SUBJECT: OYSTER CREEK NUCLEAR GENERATING STATION, - STAFF ASSESSMENT OF THE RESPONSE TO 10 CFR 50.54(f) INFORMATION REQUEST – FLOOD-CAUSING MECHANISM REEVALUATION (CAC NO. MF6111; EPID L-2015-JLD-0013)

STAFF ASSESSMENT BY THE OFFICE OF NUCLEAR REACTOR REGULATION

OYSTER CREEK NUCLEAR GENERATING STATION

Figure 3.2-1. Site Layout and Topography, Locations of Barriers, and FLO-2D Model Boundary for the Oyster Creek Nuclear Power Reactor Site (modified from Exelon, 2016b, Figure 2).

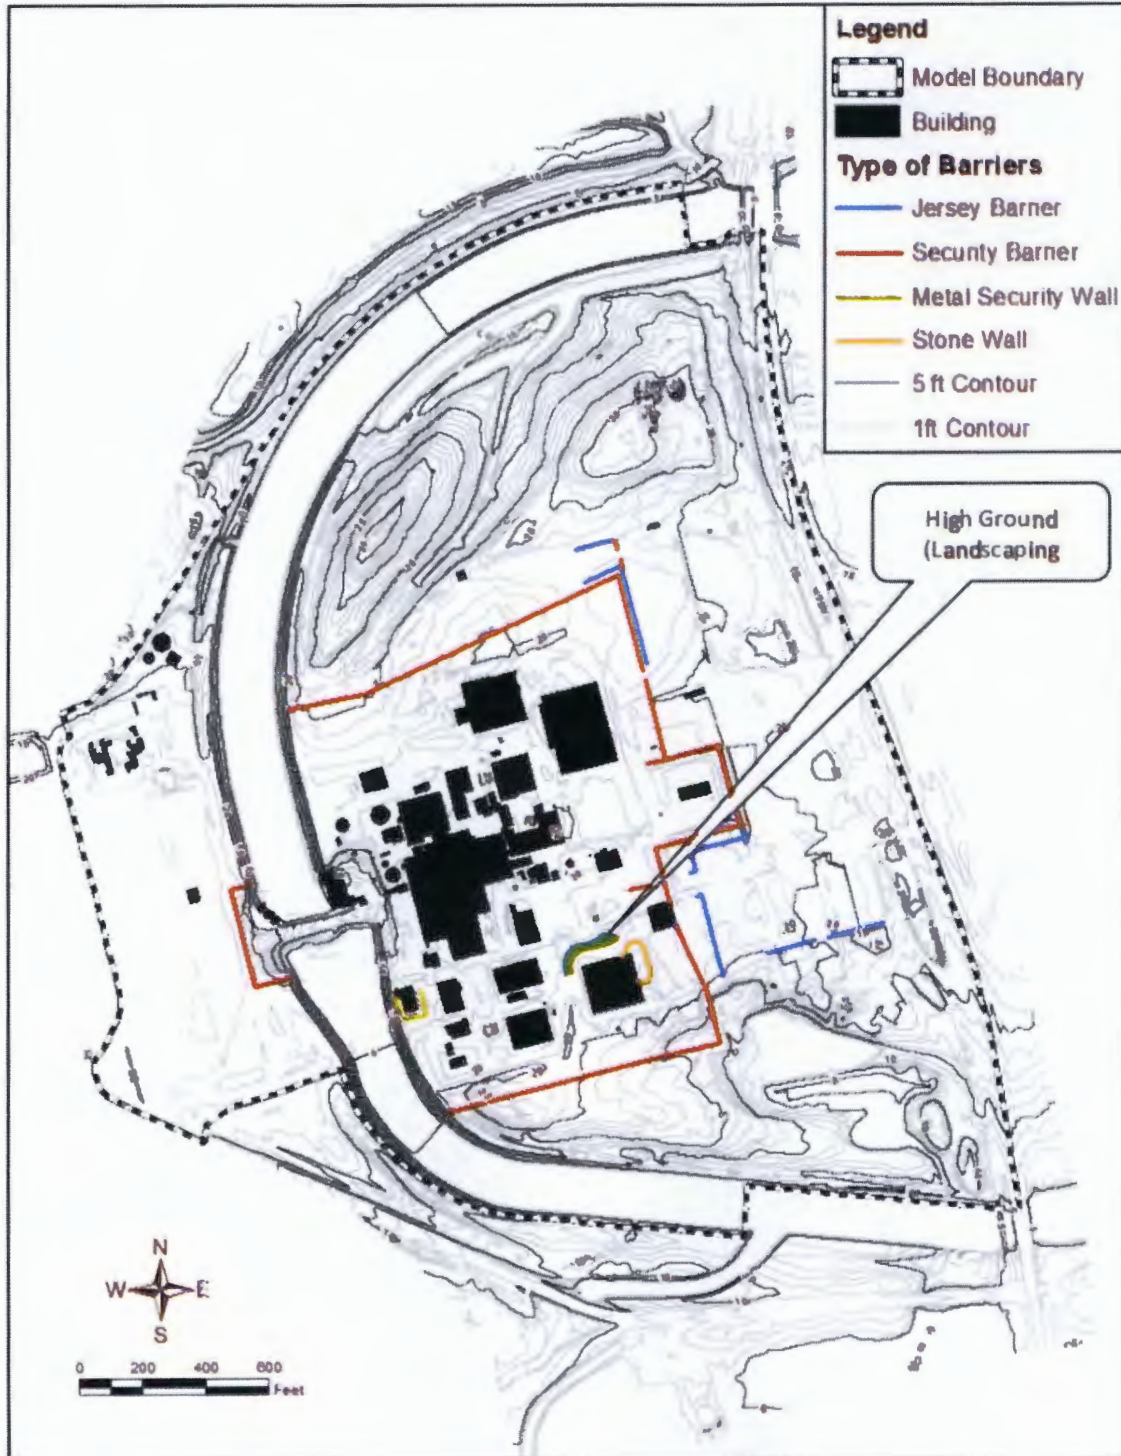
The licensee represented all barriers and other as-built features within the powerblock that could affect flow as levees in the FLO-2D computer model. The licensee assumed the gaps in the security barriers were blocked if they were smaller than 10 ft. the size of the FLO-2D model grid elements. The licensee also assumed a gap in the northeast side of the metal security barrier around the Diesel Generator Building to be open.

The licensee used an outflow boundary around the entirety of the model domain, including the outer bank of the intake and discharge canals (see Figure 3.2-1) (NRC, 2016d). The licensee also assumed that the LIP event did not occur coincident with a river flood (Exelon, 2016b).

Flooding in Oyster Creek or the South Branch of the Forked River would result in higher WSEs in the intake and discharge canals forming portions of the FLO-2D computer model boundary. The licensee stated that any overflow from the discharge canals would be directed toward the outer boundaries of the modeling domain because the power block and switch yard areas represent the high-ground topographically within the modeling domain (NRC, 2016d). The licensee also stated that, because of this elevation difference, the modeling choices for the intake and discharge canals and the model boundary would have no effect on the estimated LIP flood elevations in the power block area (NRC, 2016d). The NRC staff used the model files provided by the licensee and determined that the licensee's model configuration resulted in LIP-based flood elevations of about 5 ft. MSL in the intake and discharge canals. The licensee stated that the CDB PMF elevation in Oyster Creek is also about 5 ft. MSL (Exelon, 2009). The licensee discussed reevaluated PMF discharge in the FHRR (Exelon, 2015), but did not provide the corresponding elevation. Because the power block elevation is significantly higher than the PMF elevation in the canals, the NRC staff confirmed that the modeling choices for the canals will have a minimal effect on the LIP flood elevations within the powerblock. Therefore, the NRC staff determined that the licensee's approach to modeling the canals is reasonable.

Figure 3.2-2. Cumulative Rainfall Depth for the 1-hr, 1mi² PMP at the Oyster Creek Nuclear Power Reactor Site (modified from Exelon, 2016a, Figure 3).

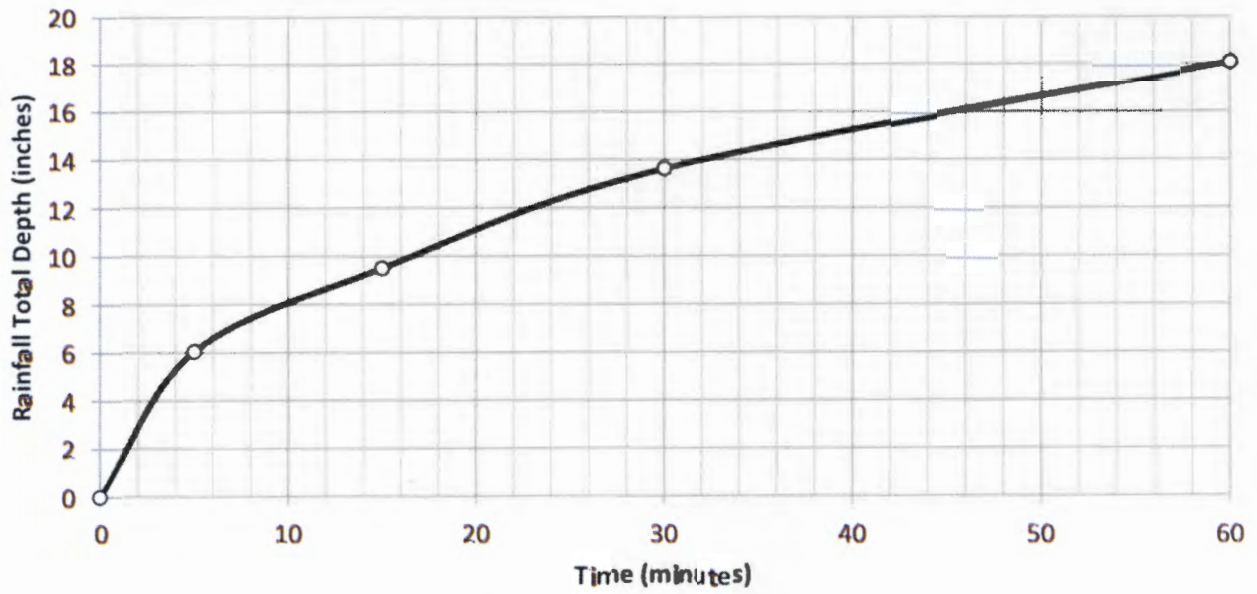
The licensee provided a depth-duration plot for the PMP precipitation, shown in Figure 3.2-2. The licensee applied the most intense precipitation during the initial 5-min increment with the precipitation rate decreasing during successive time increments. The NRC staff verified that the licensee followed the example of NUREG/CR-7046 (NRC, 2011e), Appendix B, and that, given the PMP values, the hyetograph used by the licensee would result in the most rapid rise in water levels at the site.

Figure 3.2-3. Maximum Flood Elevation in the Powerblock Area at the Oyster Creek Nuclear Power Reactor Site Calculated using the Licensee's FLO-2D I/O files. Grid cells with elevations greater than 24.5 ft. represent buildings.

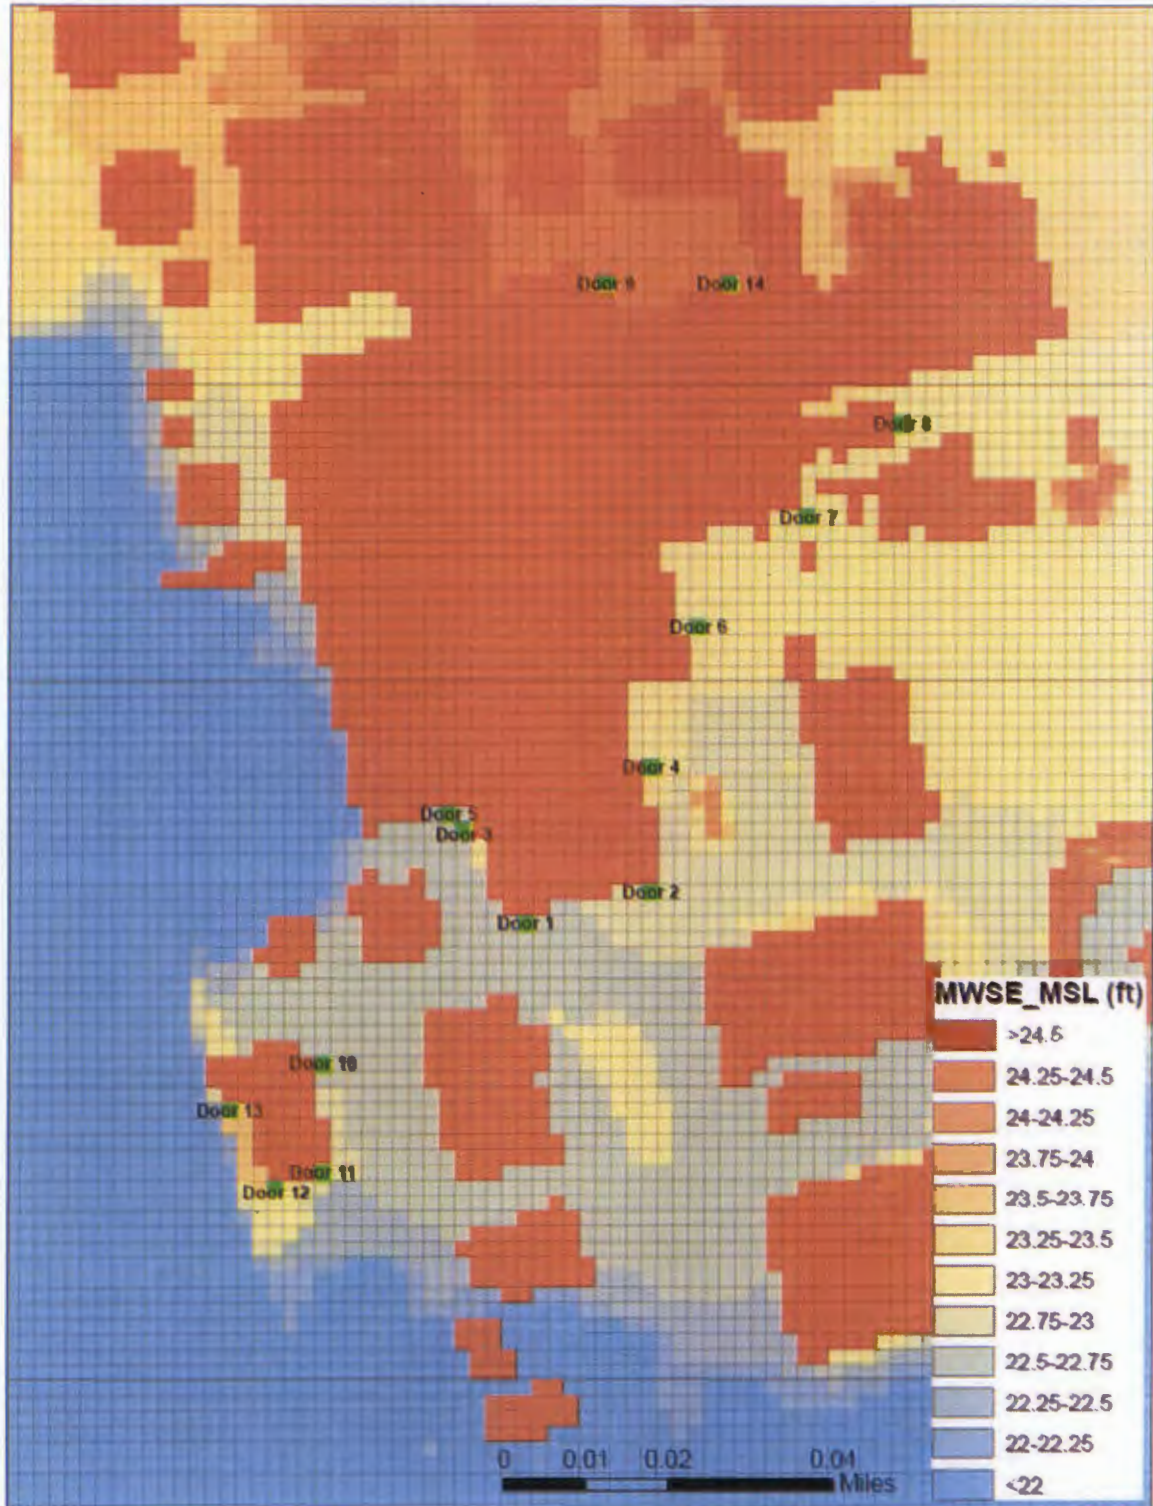
Using the FLO-2D model files provided by the licensee, the NRC staff confirmed the licensee's results described above and in Exelon (2016a). Maximum flood elevations in the power block area, as calculated from the FLO-2D model, are shown in Figure 3.2-3. The NRC staff determined that the licensee's approach was consistent with and supported by the available information, ANSI/ANS (1992), and NUREG/CR-7046 (NRC, 2011e). The NRC staff confirmed the reevaluated flood hazard elevations provided by the licensee.
